LORMEL DEVELOPMENTS (BRADFORD) LTD.
PURCHASER EXTRAS

LOT - 113 P.E #002 -- Ashbury – 2350 Elev.C

Schedule B-3 – Purchaser’s Extras

MODEL: Ashbury 2350

FIRST FLOOR ELEVATION A, B, C

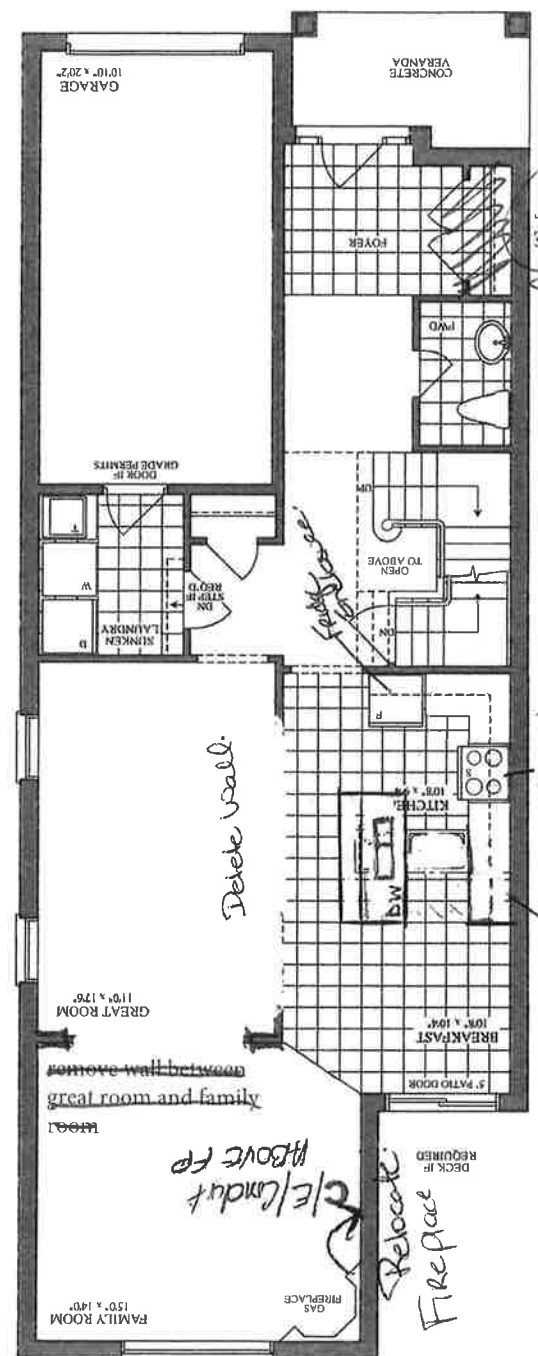
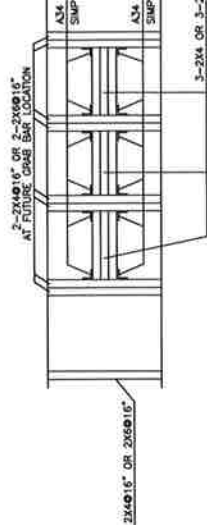
DELETE CLOSET

Delete Wall

Re Center Stair

Kit 6'x6'

Relocate Fire place
K/E/Landsc
Above FP

remove wall between great room and family room

COMPANY: Lornel Homes
SITE: Bradford Ph3
MODEL: 2350-Asbury-GRH
DATE: Sep. 9/20

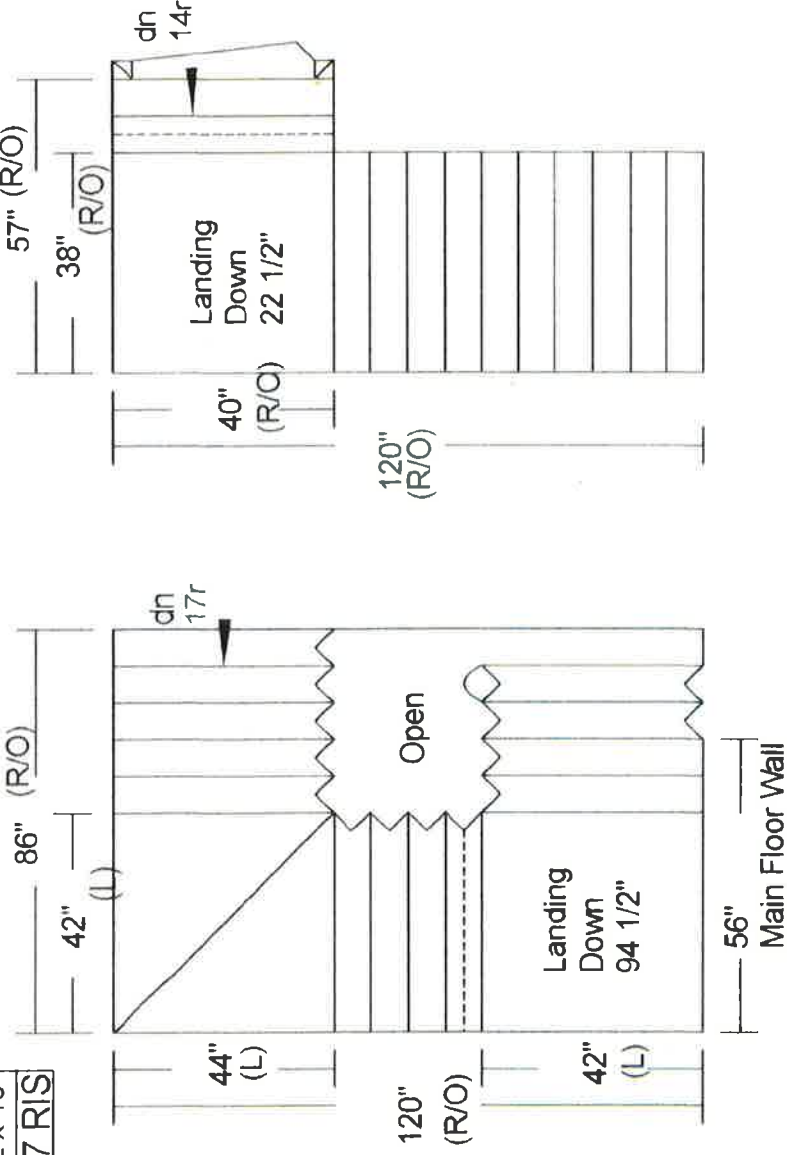
2 x 10
17 RIS

10' CEILING

8 1/2"
RUN
